**CITY OF TEMPE
DEVELOPMENT REVIEW COMMISSION**

**Meeting Date: 01/13/2015
Agenda Item: 2**

ACTION: Request for a Development Plan Review consisting of a new restaurant building for TILTED KILT, located at 1617 West Warner Road. The applicant is Big Red Rooster Architecture.

DPR14275 Development Plan Review including site plan, building elevations, and landscape plan.

DR1.0
PC#140108

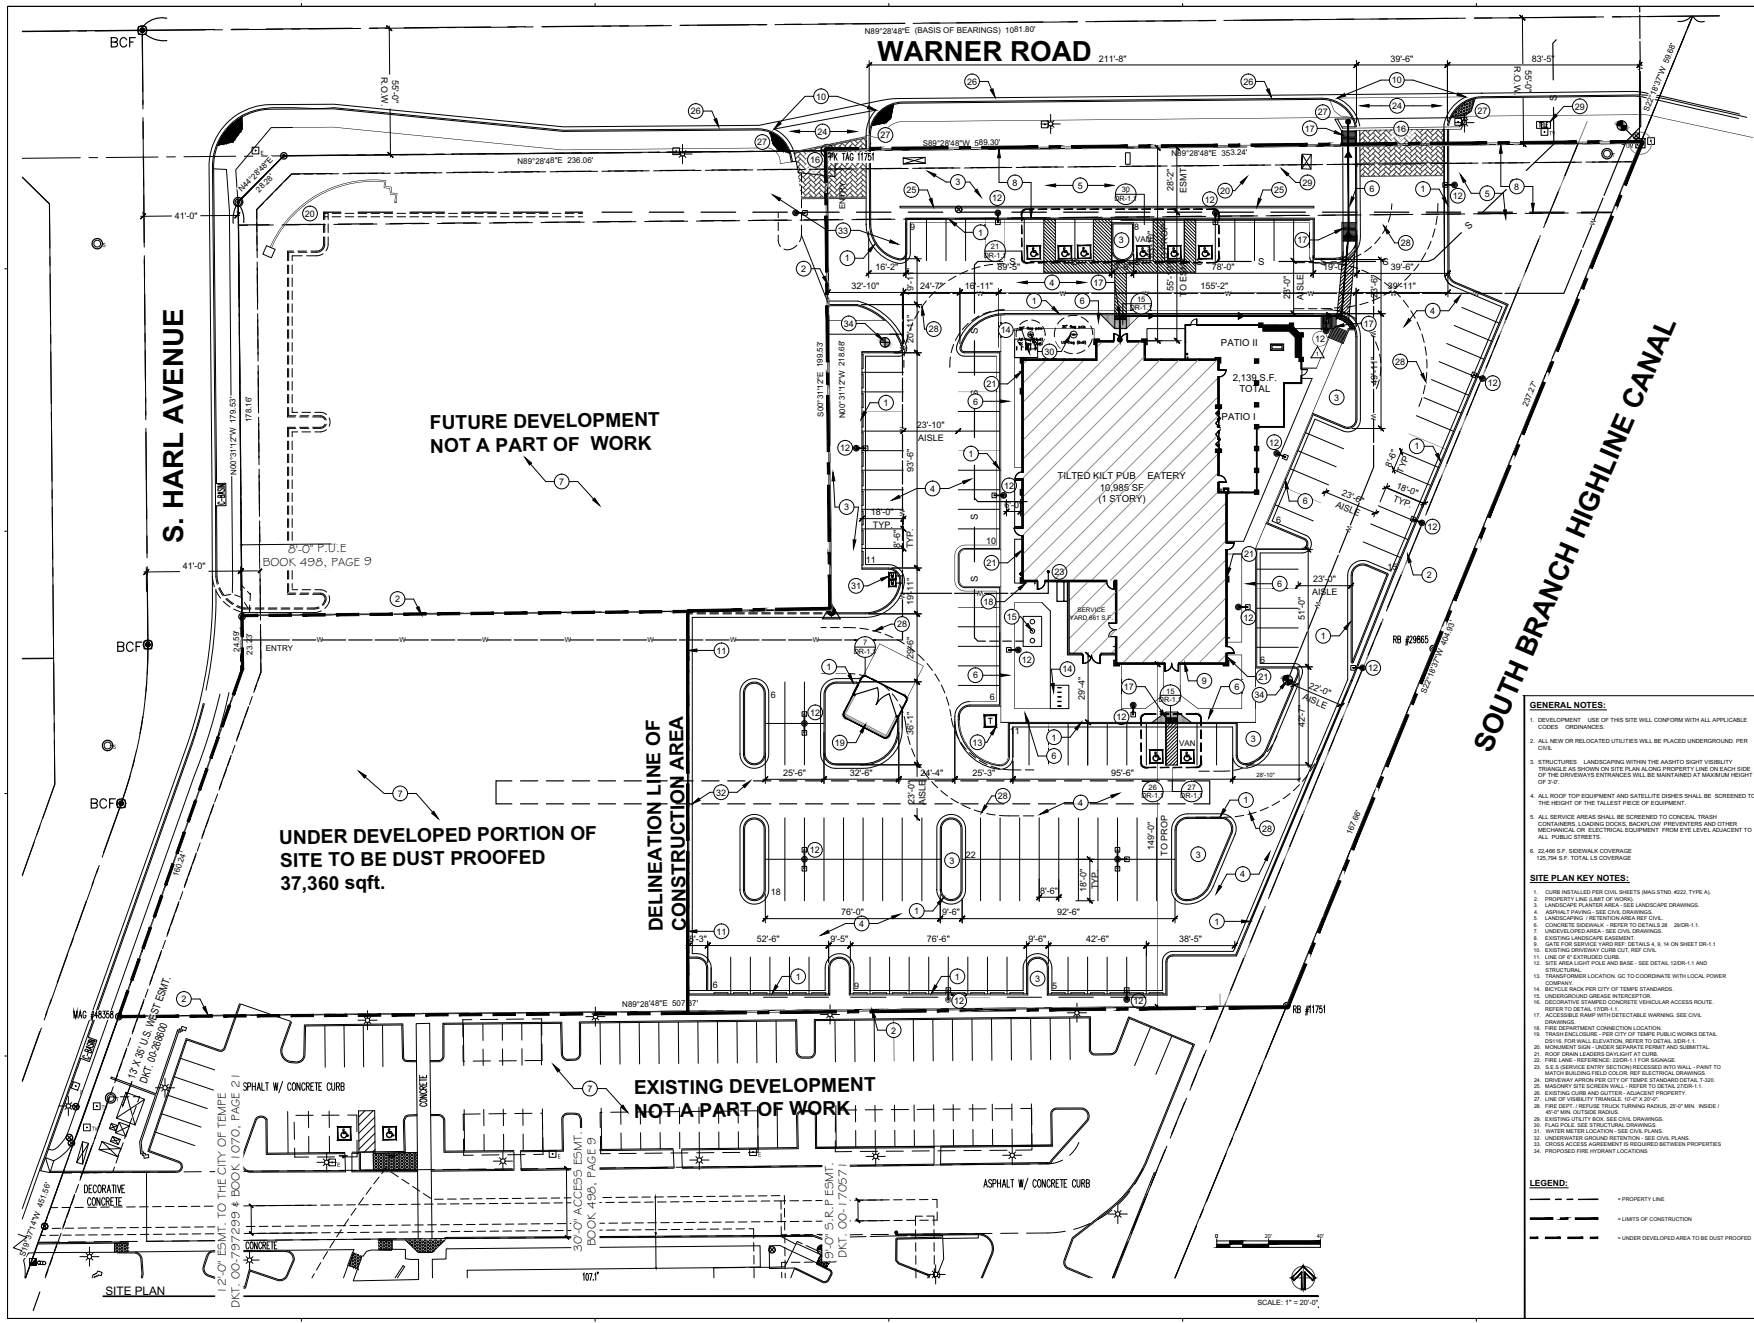
2. The front parking curb along Warner Road shall be setback or aligned with the private 30' wide landscape easement for the street frontage.
3. An existing cross access agreement between adjoining properties to the south shall be abandoned. Otherwise, the site plan shall be modified to accommodate cross access between the properties. Termination of such easement shall be provided to the Community Development Department prior to receiving building permits.

4. Prior to issuance of Certificate of Occupancy, provide verification of cross access agreement for shared driveways to the development site.
5. Development shall include a two-way paved drive aisle along the north edge of the undeveloped portion of the site and a driveway on Harl Avenue.

6. Provide 8'-0" wide public sidewalk along arterial roadways, or as required by Traffic Engineering Design Criteria and Standard Details. Sidewalk details and connection to the public sidewalk shall be consistent with the Southwest Tempe Overlay District sidewalk detail T-351.

7. Provide upgraded paving at each driveway entrance consisting of exposed aggregate, to match sidewalk details of the overlay district. Extend this paving in the driveway from the right-of-way line to 20' on site and from curb to curb at the drive edges. From sidewalk to right-of-way line, extend paving to match sidewalk.

8. A pathway shall be provided from the building to the canal easement along the east property line.
9. Provide gates of steel vertical picket, steel mesh, steel panel or similar construction. Where a gate has a screen function and is completely opaque, provide vision portals for visual surveillance. Provide gates of height that match that of the

2 EXTERIOR ELEVATION - EAST SCALE: 1/8" = 1'-0"

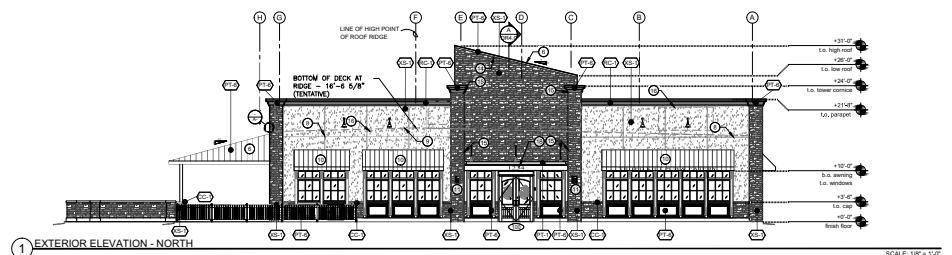
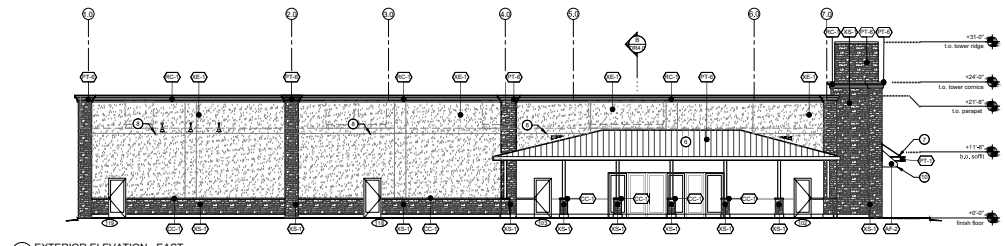
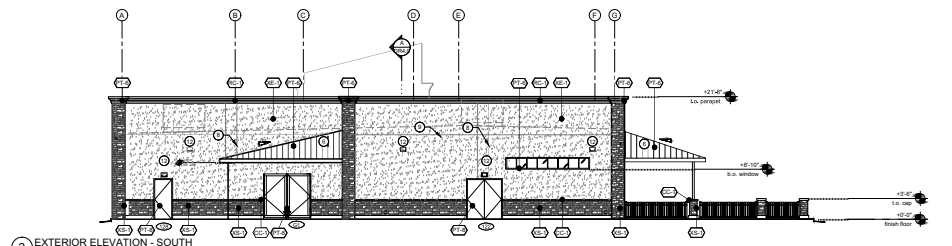
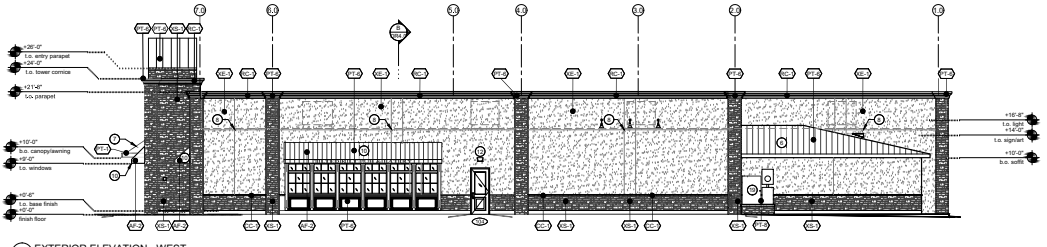
14. Add windows to the east building elevation to break up the flat, blank façade.
15. Provide secure roof access from the interior of the building. Do not expose roof access to public view.
16. Conceal roof drainage system within the interior of the building.
17. Incorporate lighting, address signs, and incidental equipment attachments (alarm klaxons, security cameras, etc.) where exposed into the design of the building elevations. Exposed conduit, piping, or related materials is not permitted.
18. Locate the electrical service entrance section (S.E.S.) currently shown on the west side of the building either inside the building or inside the service yard.
19. Upper/lower divided glazing panels in exterior windows at grade level, where lower glass panes are part of a divided pane glass curtain-wall system, shall be permitted only if laminated glazing at these locations is provided.
